# **Appendix M Consultation**

**RE: Winston Churchill Boulevard Improvements from Highway 401 to  
Embleton Road/5 Side Road, Regional Municipalities of Peel and Halton  
Class Environmental Assessment Study**

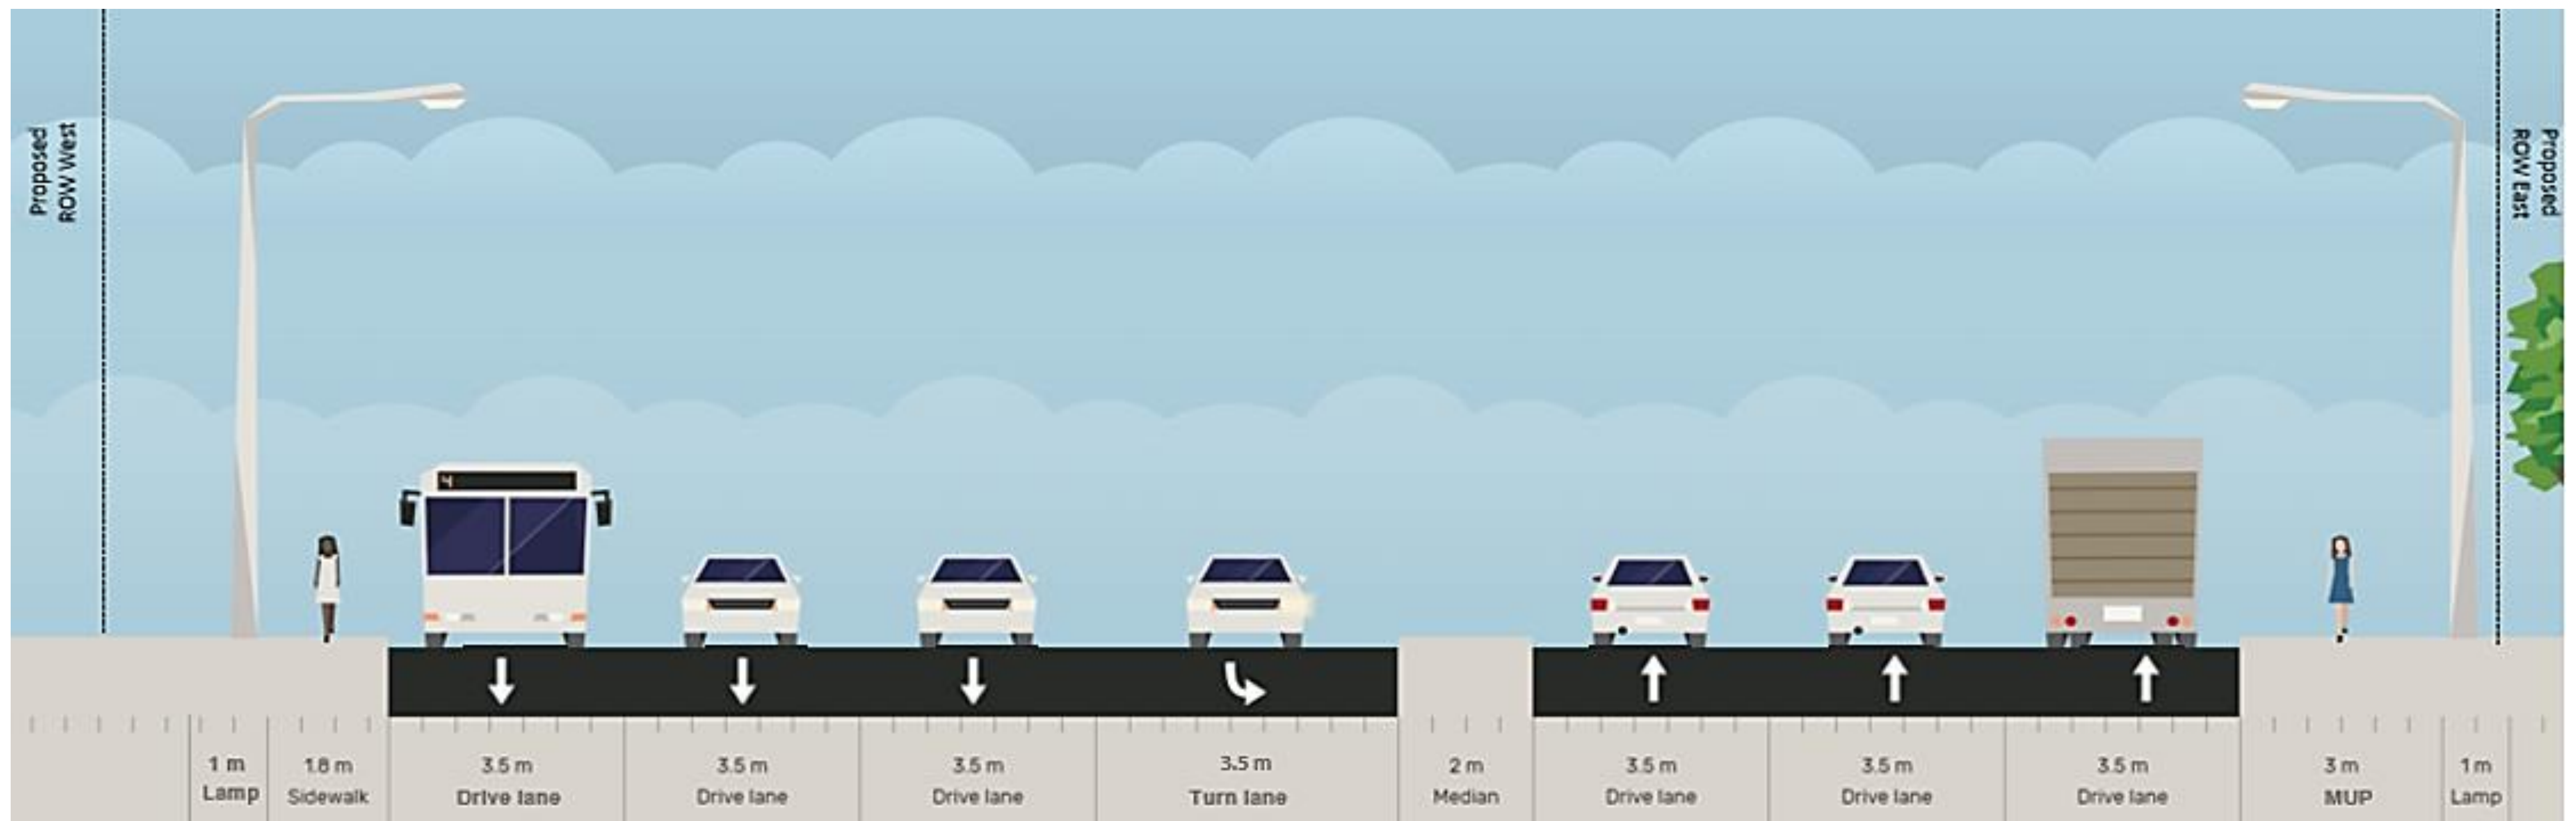
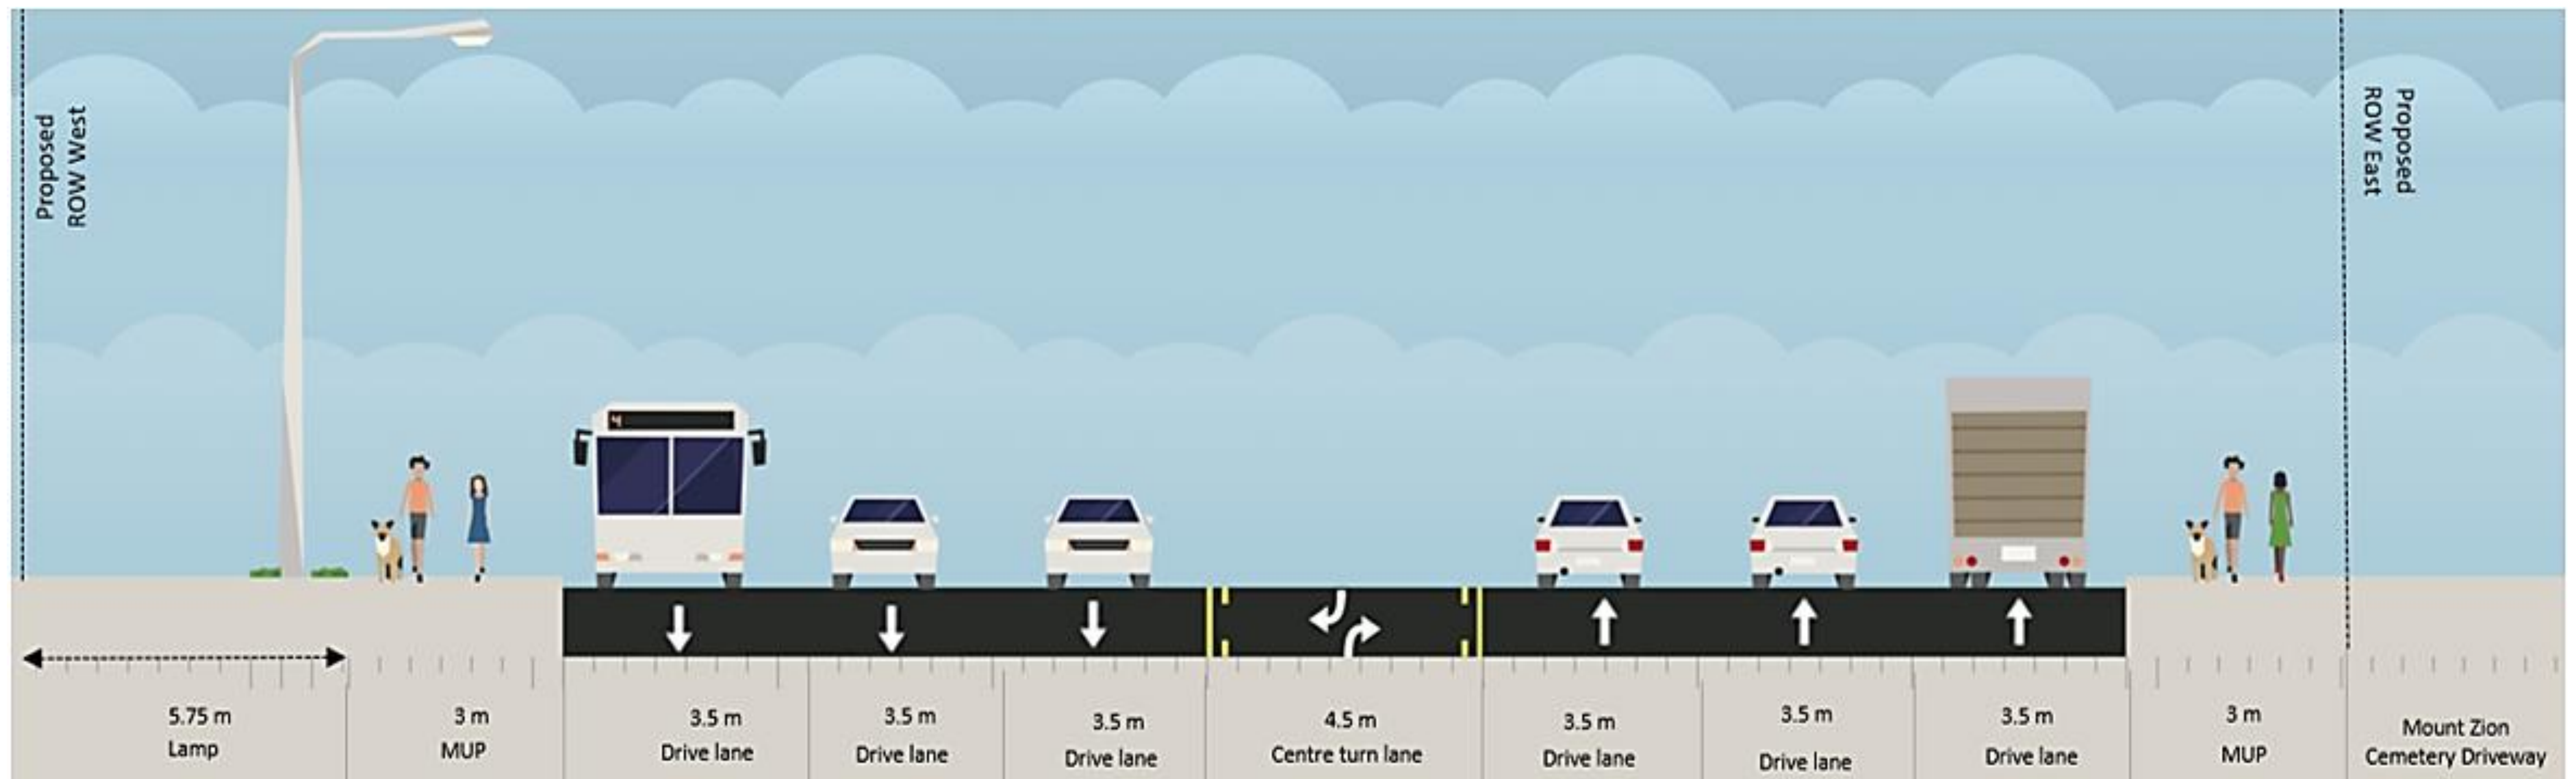
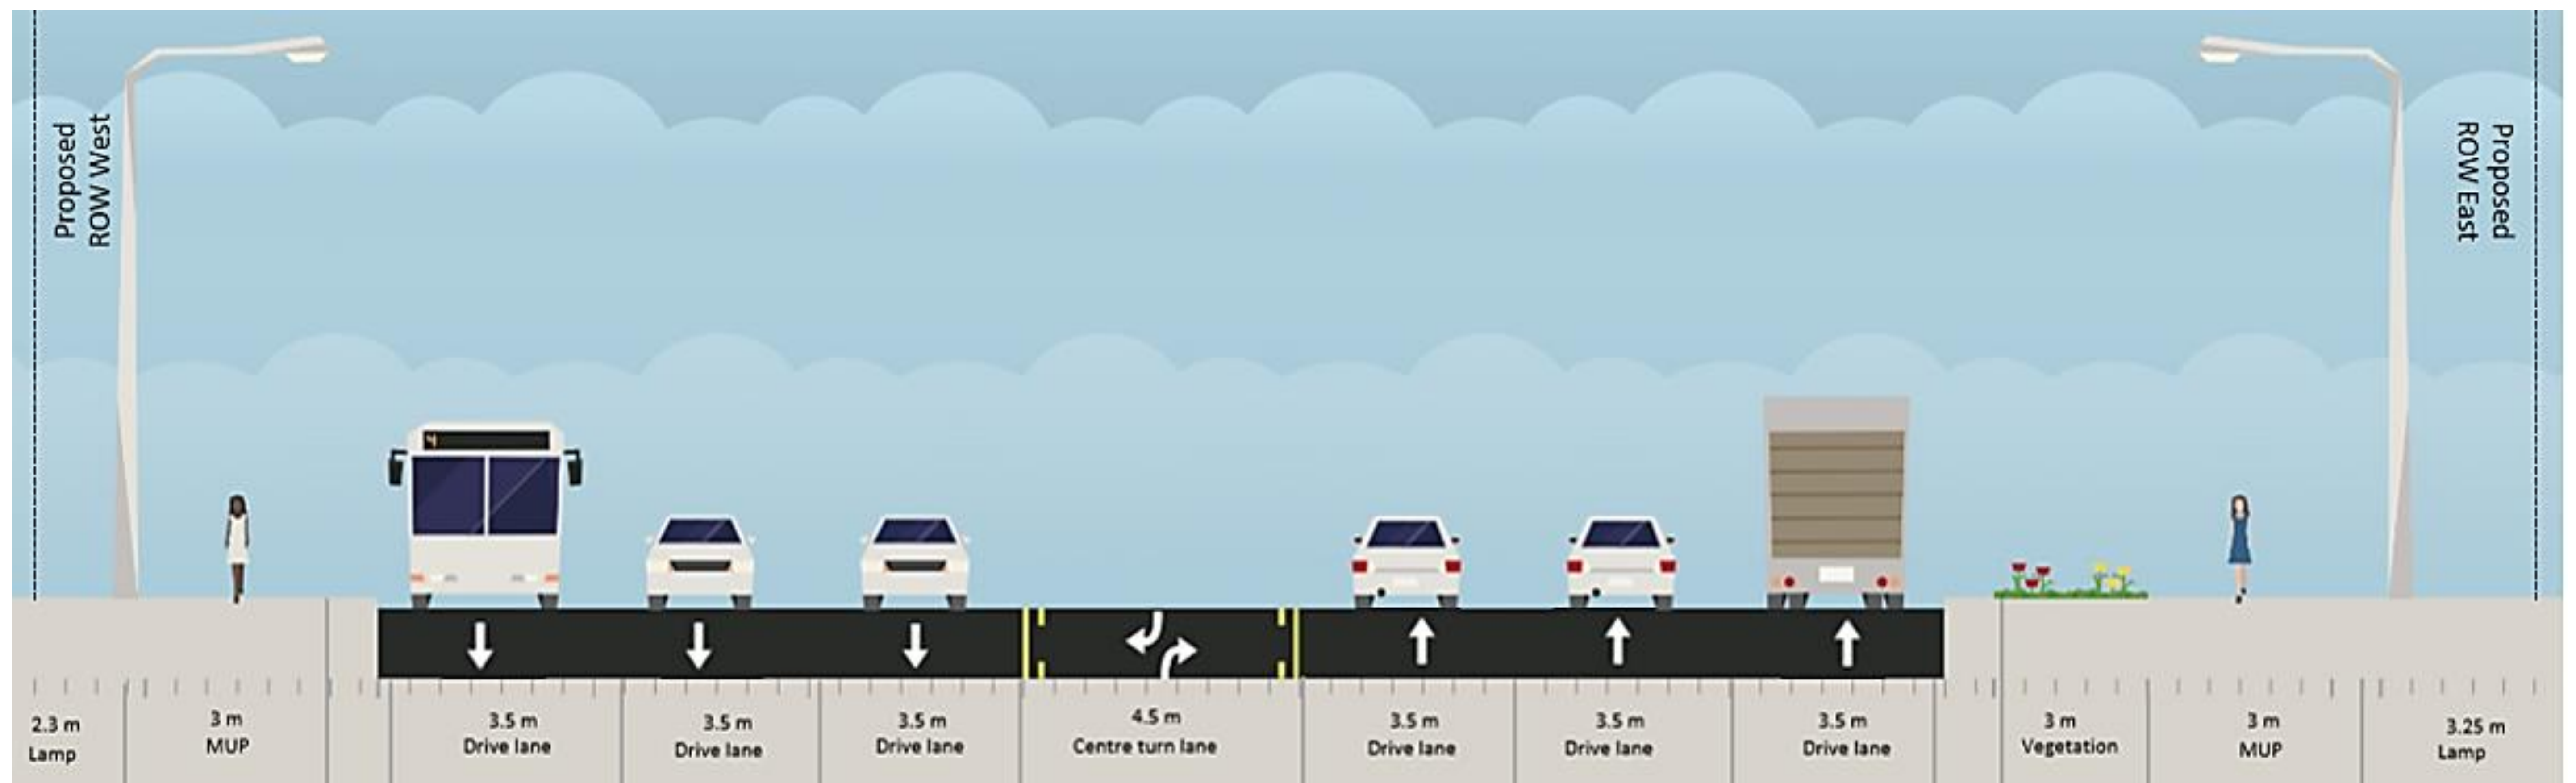
In PIC #1, Winston Churchill Boulevard was identified as an Industrial Connector within the Regional Road Characterization Study. The cross-sections included with the slide deck for PIC#2 are not reflective of what is intended as an Industrial Connector. Cross-sections included within the slide deck should be revised to include more "green zone" and the green zone should be strategically placed - as depicted on the sample cross-sections attached. *fig 1 & fig 2* (i.e. between the road and pedestrian realm).
